The Commission has issued the enclosed Amendment No. 48 to Facility Operating License No. DPR-67 for St. Lucie Unit No. 1. This amendment consists of changes to the Technical Specifications in response to your applications dated November 14, 1980 and September 28, 1981.

The amendment changes License Condition 2.C.(1) and the Technical Specifications to authorize operation of St. Lucie Unit 1 at 2700 Megawatts thermal power. The previously authorized maximum power level was 2560 Megawatts thermal.

ST. LUCIE PLANT UNIT NO. 1

Amendment No. 48
License No. DPR-67

FIGURE 3.2-4
 AXIAL SHAPE INDEX Operating Limits With 4 Reactor Coolant Pumps Operating

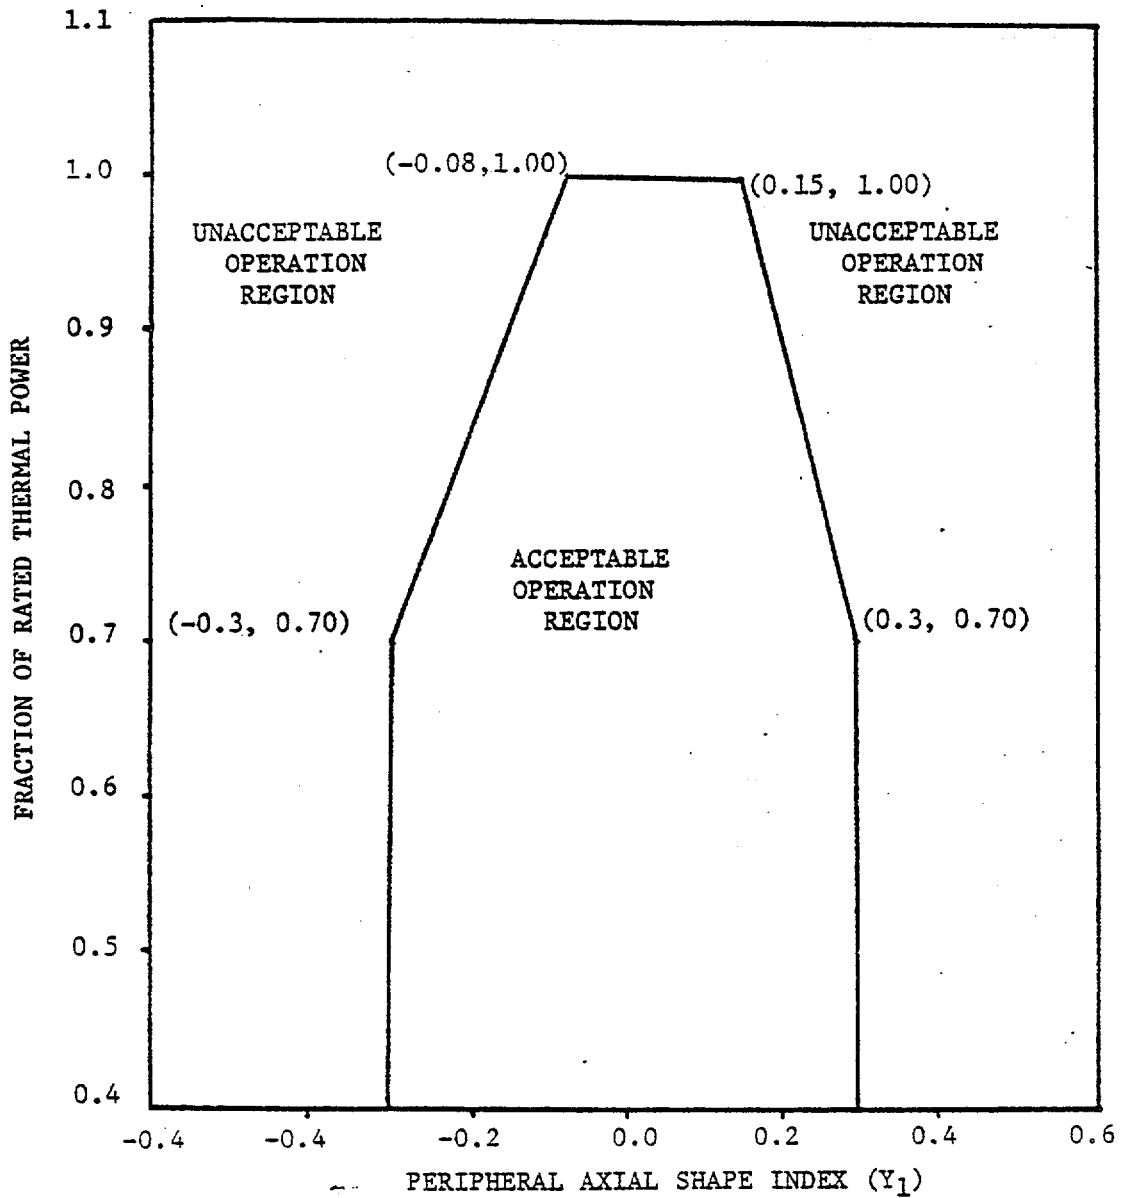
Technical Specification Figure 3.2-2, page 3/4 2-4 and Figure 3.2-4, page 3/4 2-15

These proposed modifications to the Technical Specifications in Section C.4 have been reviewed by the staff and are acceptable.
